# Panel Decision and Report

SRP COBC073021  
Boulder County, CO

November 18, 2022

Figure 3-1 – HEC-RAS Cross-Section 62978 showing Preliminary Mapped Boundaries. Note that the mapping shows a single 1% floodplain, while the HEC-RAS output would map 3 or 4 separated floodplains.

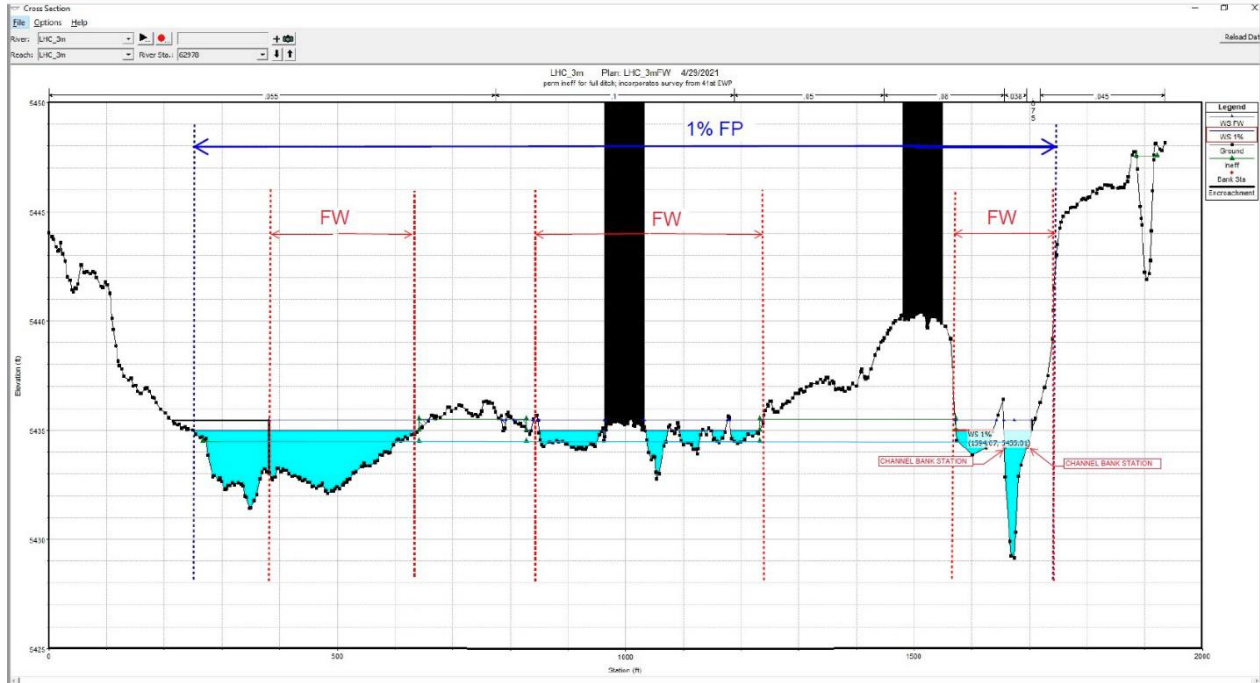
determine the 100-year flood elevations and profile for the main channel, then determine overflow locations and conditions (i.e., is it a stream junction or inline side-channel weir). They contended that when current channel and overbank conditions, including increased channel capacity and overflow spillway are considered as addressed above, estimated channel flows and overbank conditions will be substantially different from those currently modeled and shown on the proposed FIRM.

Figure 3-3 – Extent of SRH2D Modeling on Lefthand Creek.

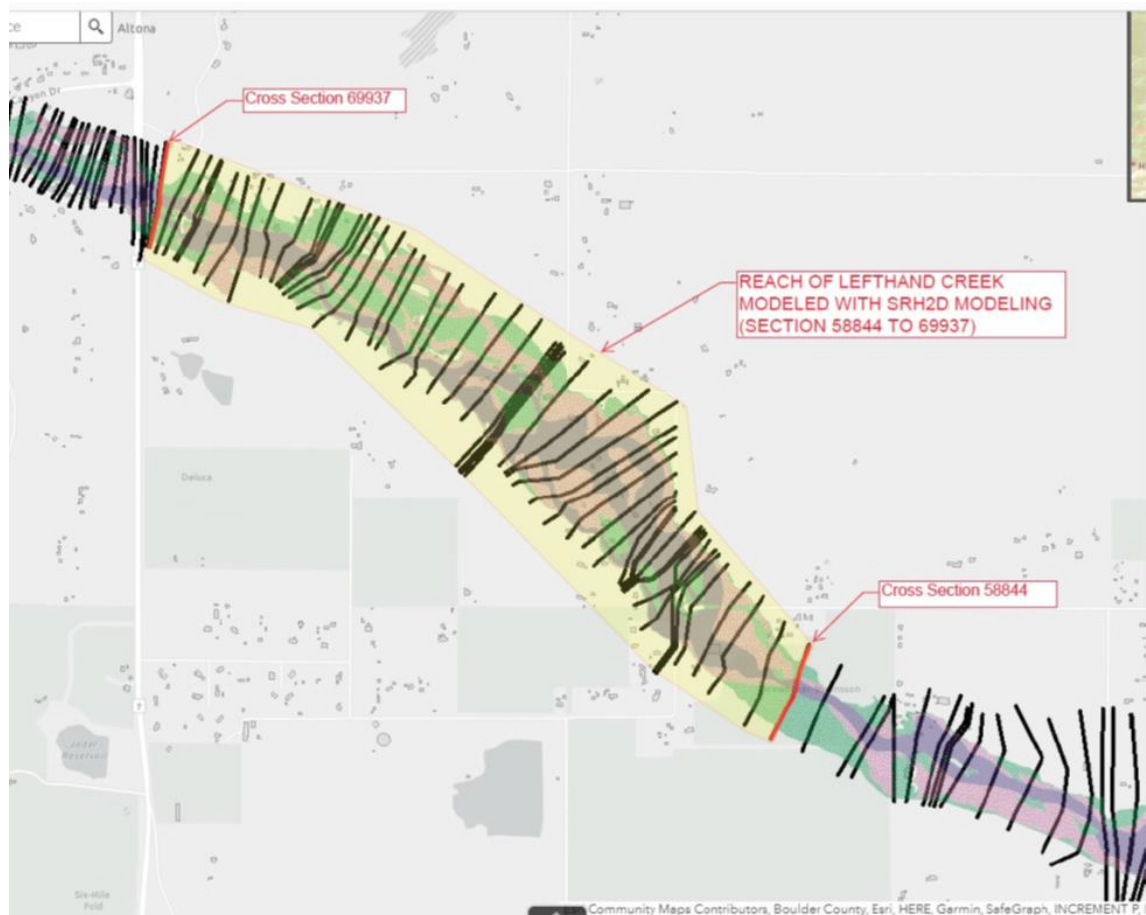
- The hydraulic HEC-RAS model results in 1% (100-year) Base Flood boundaries (shapefiles) that do not match those shown on the Preliminary floodplain mapping. It was the opinion of the appellant that this was because boundaries were determined by 2D mapping. As stated on page 20 of the AECOM Hydraulic Analysis TSDN for St. Vrain HUC-8 Watershed, Colorado, dated June 7, 2018: “An approximate model was created in SRH2D between cross sections 58844 and 69936 to inform the development of the 1D model and mapping of its results, particularly for the 1% and 0.2% profiles. Depth grids for these two profiles are included under Supplemental Data. Zone AOs were mapped based on the 2D modeling between cross sections 67446 to 65356 and 59822 to 59248”. The results of the SRH2D modeling are shown on the Colorado Water Conservation Board’s Colorado Hazard Mapping and Risk MAP Portal ([coloradohazardmapping.com](http://coloradohazardmapping.com)), including data and mapping of Depth Grids, Water Surface Elevation Grids, Velocity Grids, and overall Floodplain Mapping. Review of the CHAMPS maps show that the 100-year and 500-year boundaries (shapefiles) are identical to those shown on the proposed Preliminary floodplain maps, including the Zone AOs mapped between cross sections 67446 to 65356 and 59822 to 59248.

FEMA's study contractor, AECOM, prepared a 2D model using SRH2D between cross sections 58844 and 69936. AECOM used the 2D modeling results to map Zone AO limits in the left overbank areas between cross sections 67446 to 65356 and 59822 to 59248. However, AECOM used 1D modeling results to map floodway and floodplain limits between cross sections 65356 and 59822, which represents the mapping reach subject to this appeal. AECOM did state that the 2D modeling results were used as a check on the 1D modeling results in this reach.

Based on the panel's review of the provided materials (i.e., aerial photos, photographs, topography, HEC-RAS models), the geomorphology of the left overbank appears very similar within the entire 2D modeling limits. The abrupt change from 2D to 1D modeling and mapping through the appeal reach does not appear to accurately represent the divided flow in the left overbank. It is the Panel's opinion that the 2D modeling results should have also been used in the appeal reach to more accurately model and map shallow flooding areas in the left overbank.

Figure 4-4: Lefthand Creek area of concern and submitted elevation comparison

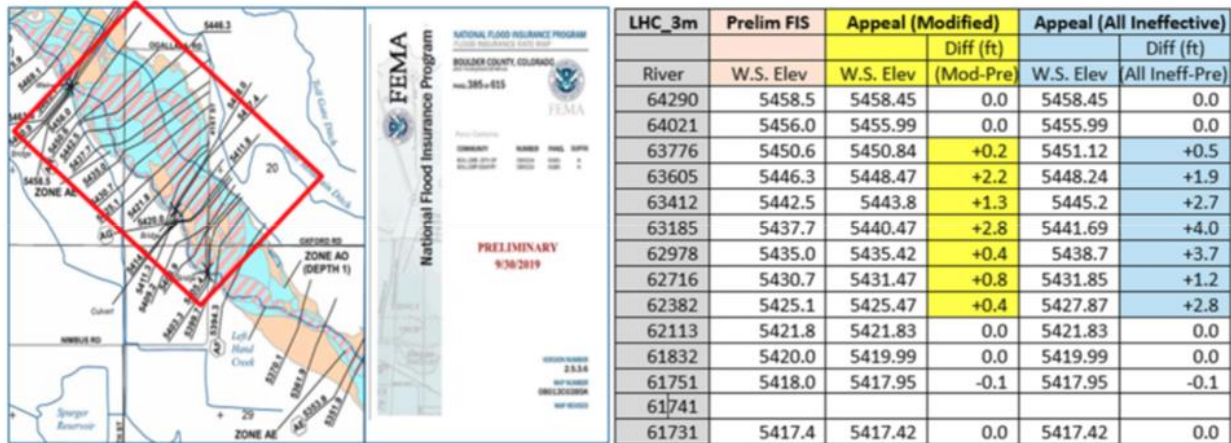
i. The methodology submitted does not support any changes to the preliminary products. As shown in Figure 1, because the submitted model’s use of ineffective areas, the Base Flood Elevation (BFE) in the channel are being raised. The increase

in the BFEs illustrates the need for the areas of concern to be within the floodway rather than be removed. The preliminary model includes the areas of concern within the floodway.

Figure 4-5: Cross Section comparison

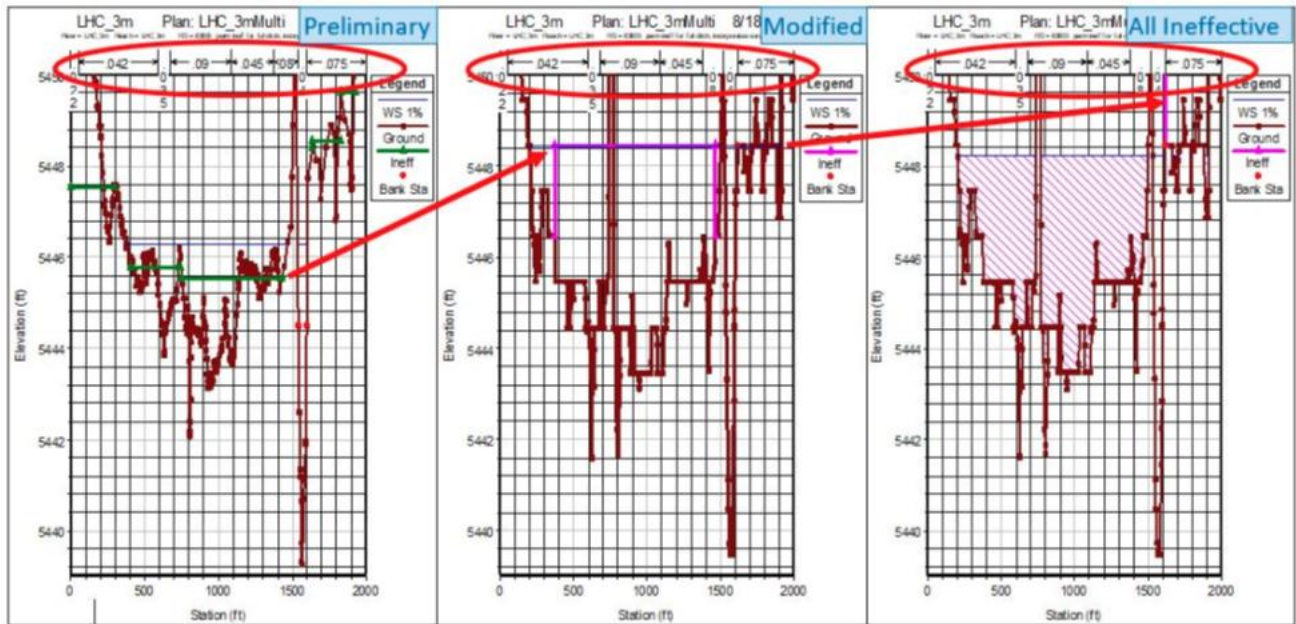
ii. The BFEs provided by the submitter are higher than the preliminary due to the applied Ineffective Flow Area as compared in Figure 2. Both models support flow in the overbank. It is unclear why additional ineffective flow is being defined when active flow is demonstrated to occur. Since that area is part of the active flow path, adding additional ineffective areas demonstrates why additional encroachments are not warranted in the overbank as they would cause a rise in the water surface elevation above the state's allowed 0.5-foot surcharge. It is recommended to revisit the ineffective flow area stations and elevations designated by submitter to determine if they are reasonable and can be justified.

Figure 7-1: Cross section orientation

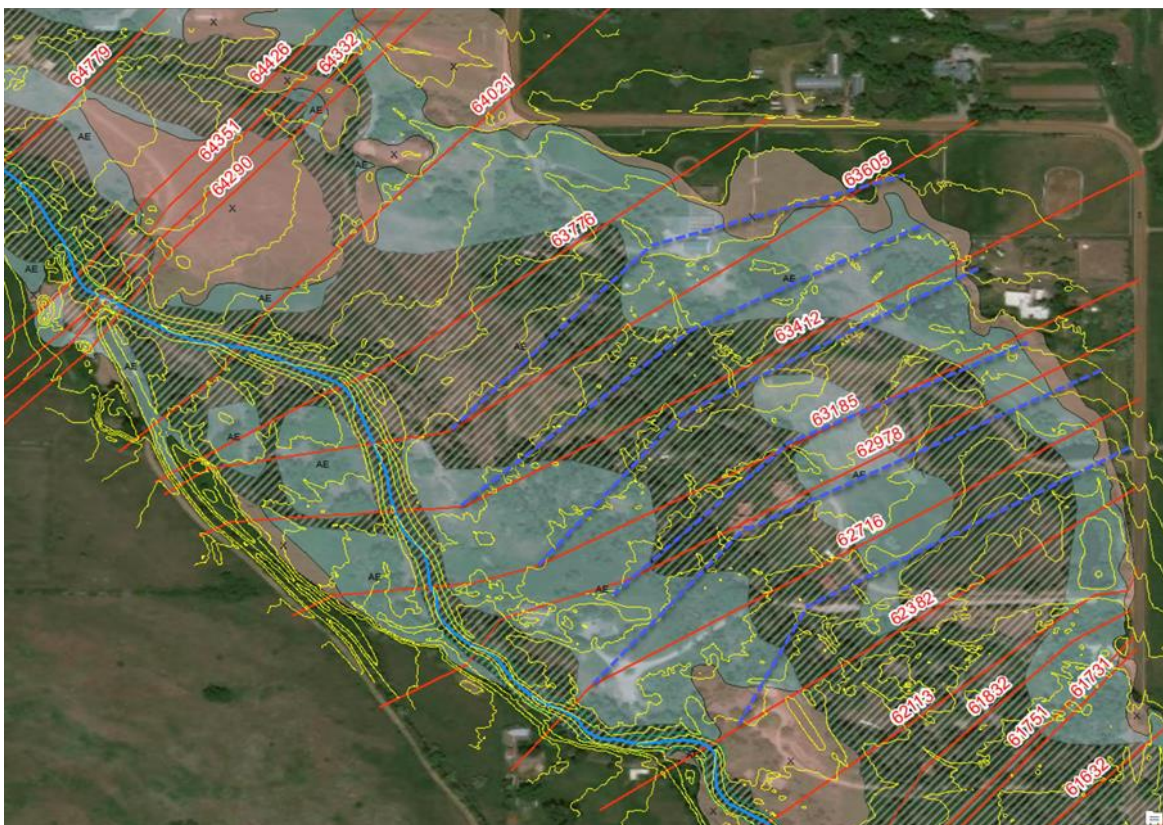
Per FEMA guidelines (FEMA, 2020) and the current HEC-RAS Hydraulic Reference Manual (HEC, 2022), “the cross sections must traverse the floodplain and be oriented perpendicular to the direction of flow,” “every effort should be made to obtain cross sections that accurately represent the stream and floodplain geometry.” In the vicinity of the disputed area, several cross sections are not perpendicular to the flow path (not aligned with the contour lines). Multiple breaking points could be used to assure cross sections are properly oriented across the floodplain. A couple of examples are shown (with blue dashed lines) on Figure 7-1. The Panel believes that should the cross sections be oriented more like the guidelines specify and as generally indicated below; the resultant calculated water surface elevations would be very different in the eastern areas of the subject area.

Figure 7-3: Top width for XS 65356 in the HEC-RAS model

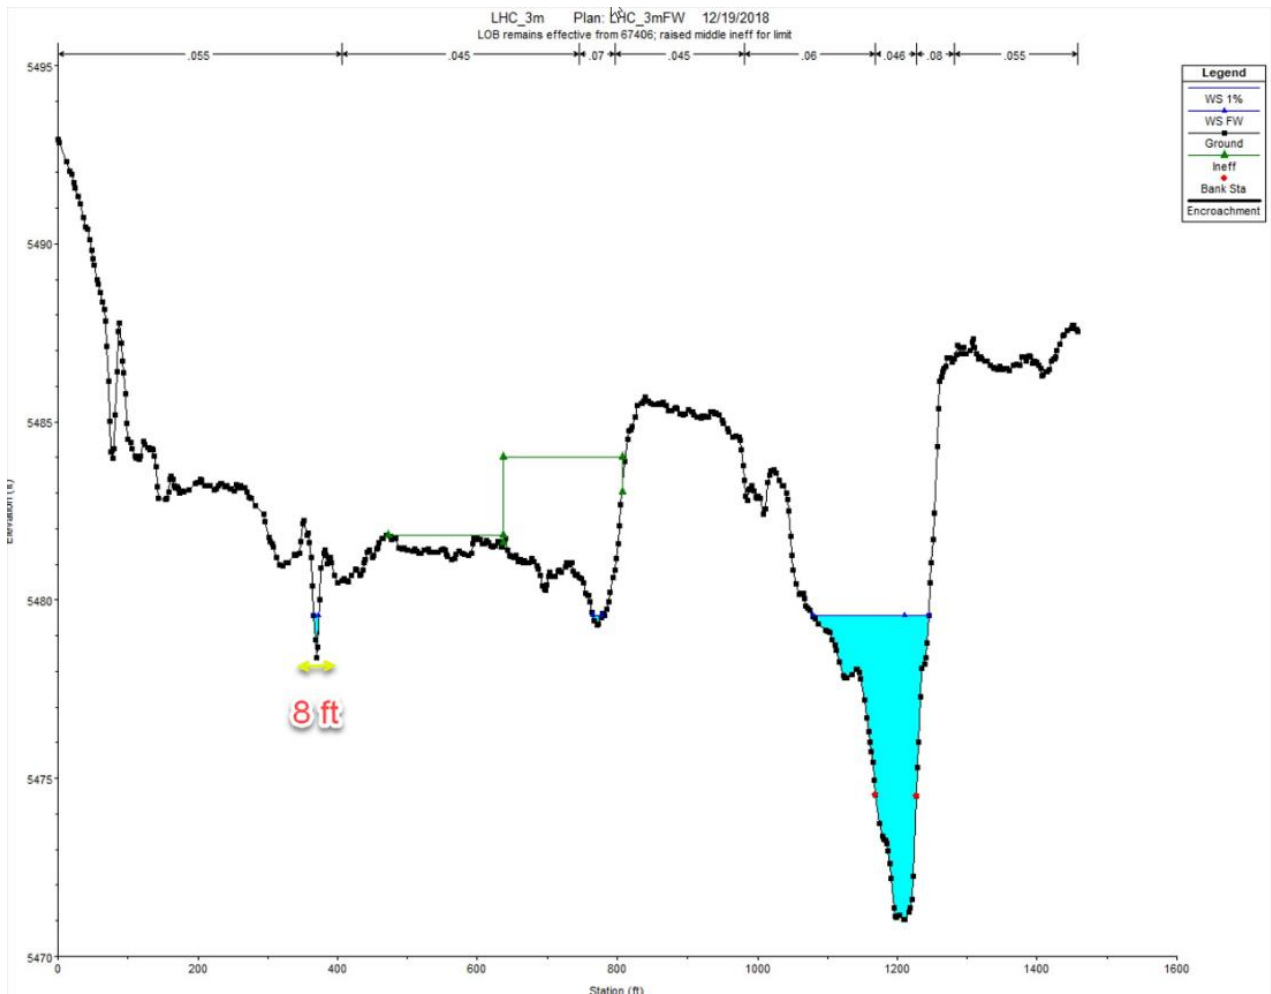
Per FEMA guidelines (FEMA, 2020) Section 3.0 Mapping of One-Dimensional Riverine Analyses, "The flood boundaries are delineated by finding the intersection of the ground surface defined by the underlying digital terrain model and the flood surface. Floodplain boundaries are delineated on the best available topographic mapping using the water-surface elevations determined at cross sections." There are discrepancies between the HEC-RAS model and the flood map in top width measurements for 100-yr floodplain extend. For example, at Cross Section 65356 the HEC-RAS model shows a top width of about 8 ft on the most left flow area. Yet, on the map at Cross Section 65356, the mapped left floodplain width measures about 85 ft.

Figure 7-5: Floodway delineation near the subject properties

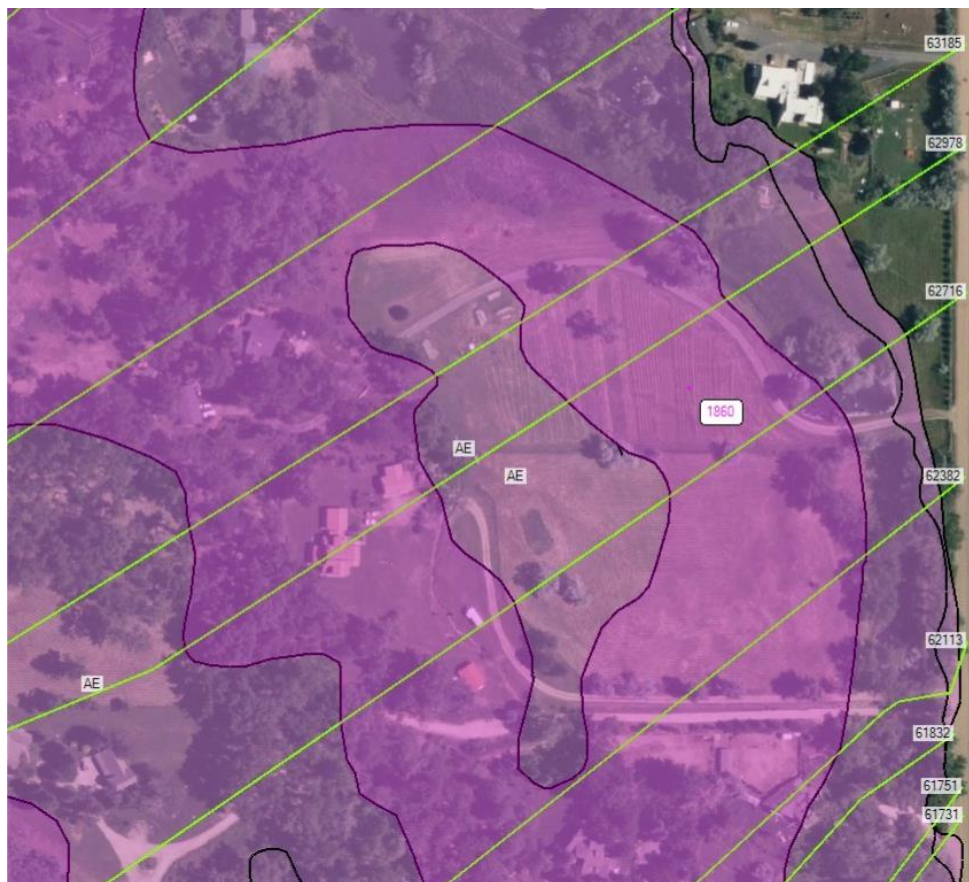
The floodway delineation process begins with hydraulic analysis by placing encroachments on the left and right overbanks of the 100-yr floodplain and gradually encroaching, following encroachment Method 4 requirements, until reaching the allowable rise in water surface elevation above the BFE (usually 1 ft). This model provides the baseline floodway encroachments, but since a floodway is a regulatory designated area, FEMA can expand it beyond the hydraulically defined boundaries to identify high hazard areas for insurance purposes. After reviewing the preliminary FIRMS, the Panel noted that floodway boundaries on the preliminary FIS maps were expanded between hydraulic cross sections XS63185-XS62716 at a few locations without any obvious underlying topographic features or obstructions. The Panel recommends review of these locations for potential re-delineations of floodway boundaries.
